Project Name: Tidal Wave Auto Spa

**CITY OF BEAUFORT
DESIGN REVIEW BOARD
Staff Report
Meeting of April 14, 2016**

Case Number: 16-04 DRB.2
Project: 9 Sam's Point Road
Property Address: Parris Island Gateway & County Shed Road
Parcel #: R123 015 000 0160 0605 (a portion of this parcel)
Zoning: General Commercial
Design District: Sam's Point Road Design District
Type of Review: Preliminary Review – New Construction

CONCEPTUAL SITE PLAN OVERLAY

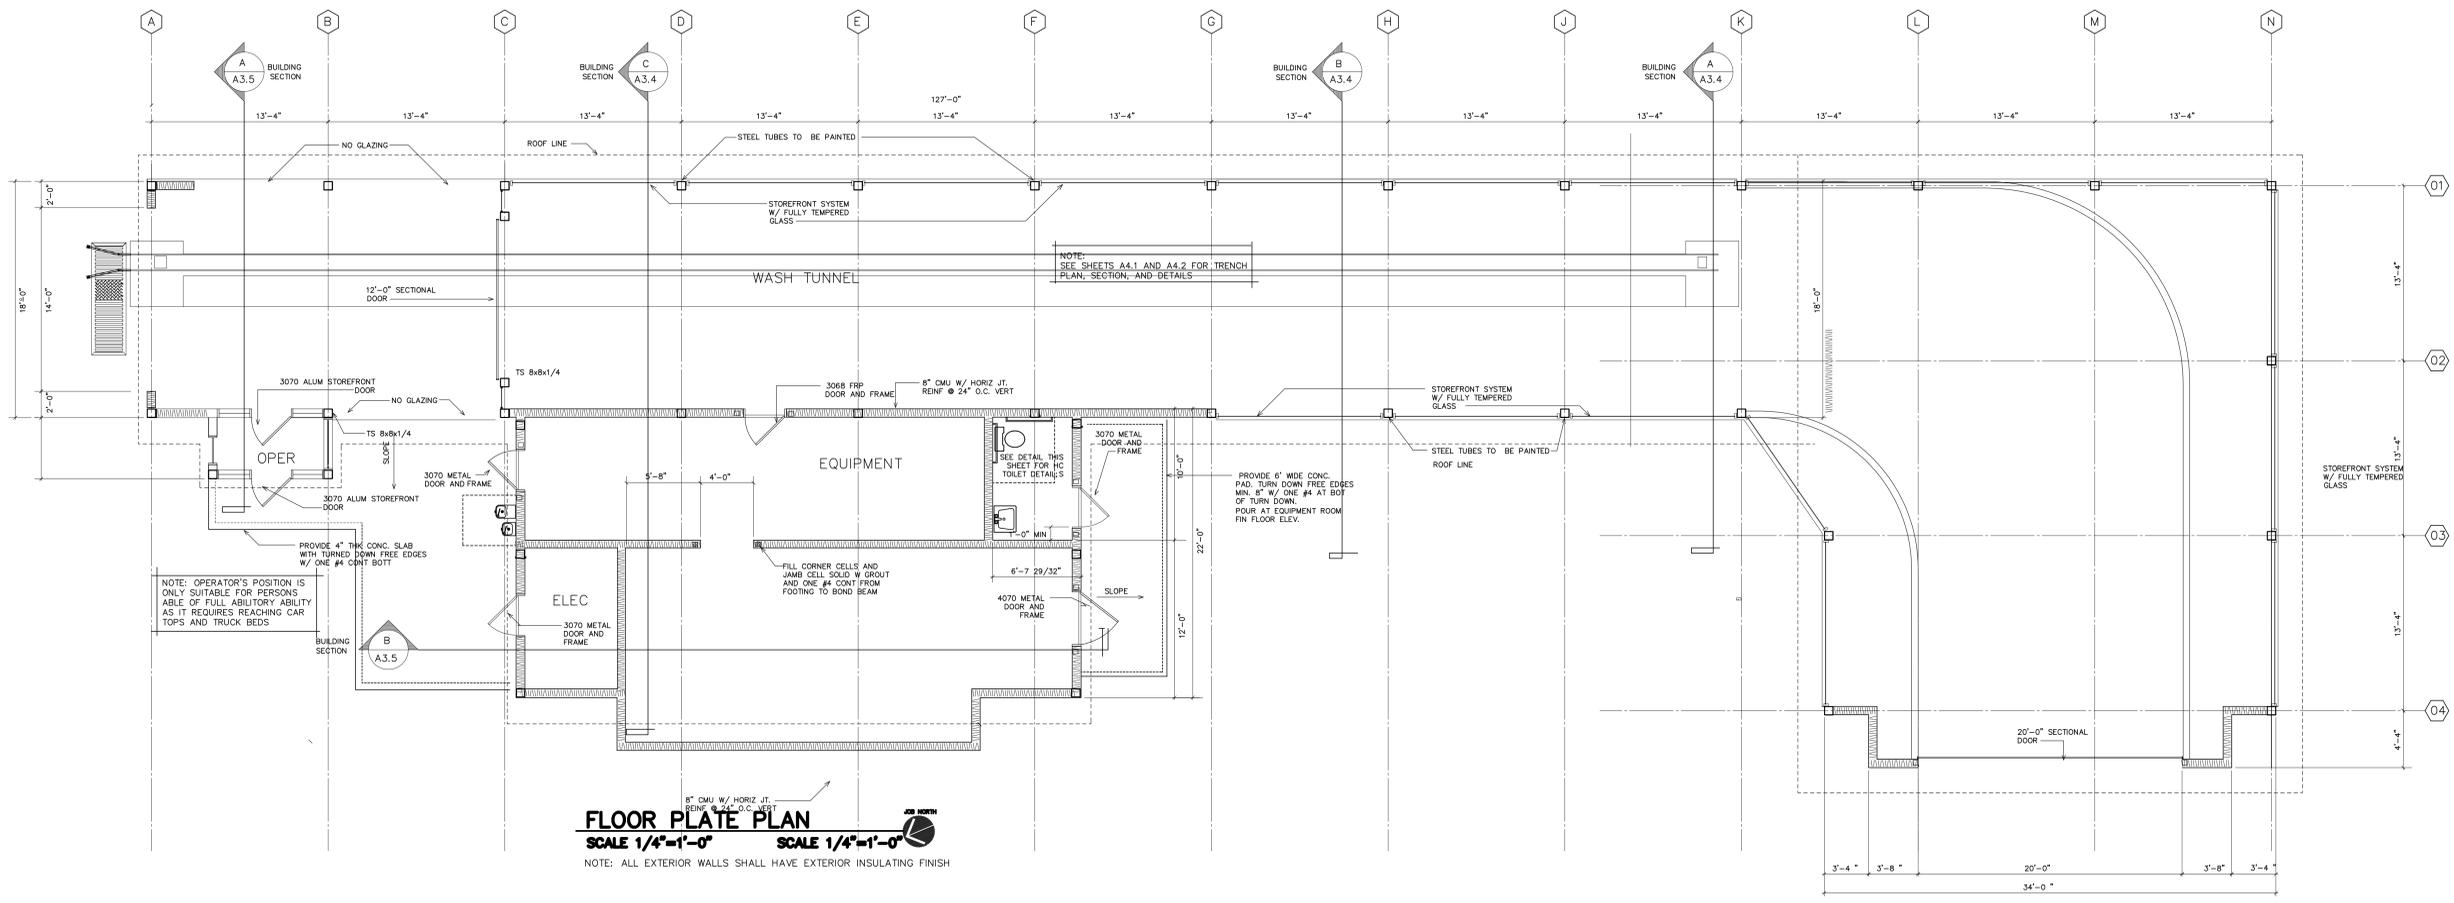
- Build-to line: the addition of the exit area, in conjunction with the new liner building satisfies the build-to requirement for this area.
- Vehicular Circulation:

- The parcel will be accessed via a shared entry between 13 and 15 Sam's Point Road. That drive will connect into the Walgreens parking lot. There are no additional curb cuts on to Sam's Point Road. This is in keeping with the connectivity recommended by the Civic Master Plan.

- Pedestrian Circulation:
 - A sidewalk connection into and through the site, at least to the main car wash building, should be established. Staff realizes that this is a vehicular-oriented business, however employees may choose to walk elsewhere for lunch, etc. so that connectivity should be provided.

- Trees:
 - Staff appreciates the effort to save the significant trees on the site. For the next submission a landscape plan will be required. In addition a tree mitigation schedule will be required.

- Stormwater: How will this be handled?
- All mechanical equipment, trash/recycling receptacles, and propane tanks must be shown on the plan. They must be screened from view and details of the screening shall be provided.

- A lighting plan, showing building and site lighting, will be required. Full-cut off fixtures are required for parking lot lighting.

REAR ELEVATION
SCALE 1/4"=1'-0"

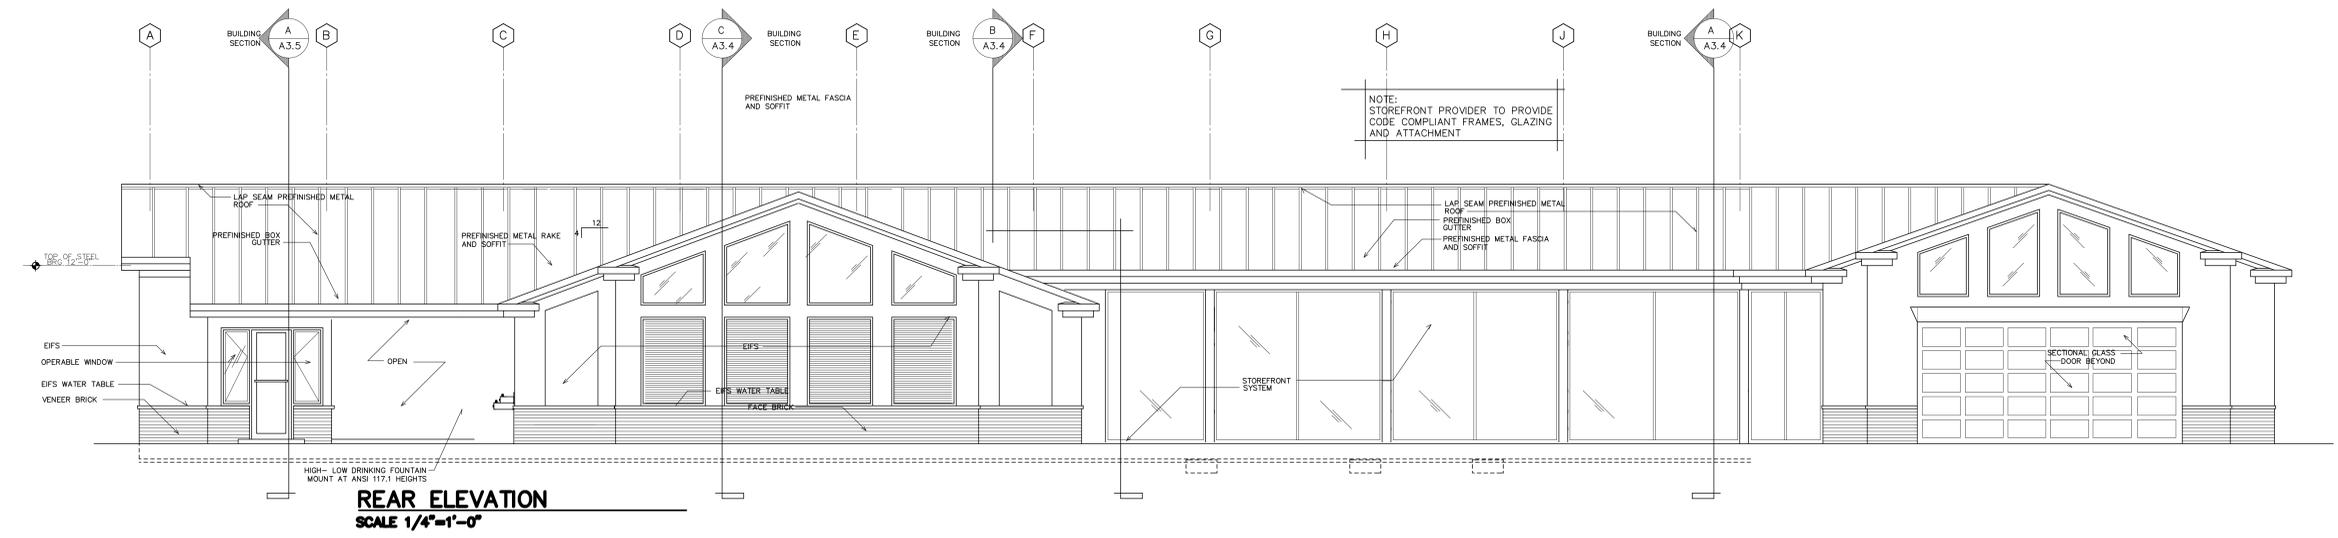
- The gables on the rear elevation have been modified to break up the massing, however maintaining the low 4:12 roof pitch keeps these still horizontally proportioned. Consider using a 6:12 roof pitch, similar to the north (Tunnel Entrance) elevation at least for the middle gable portion.
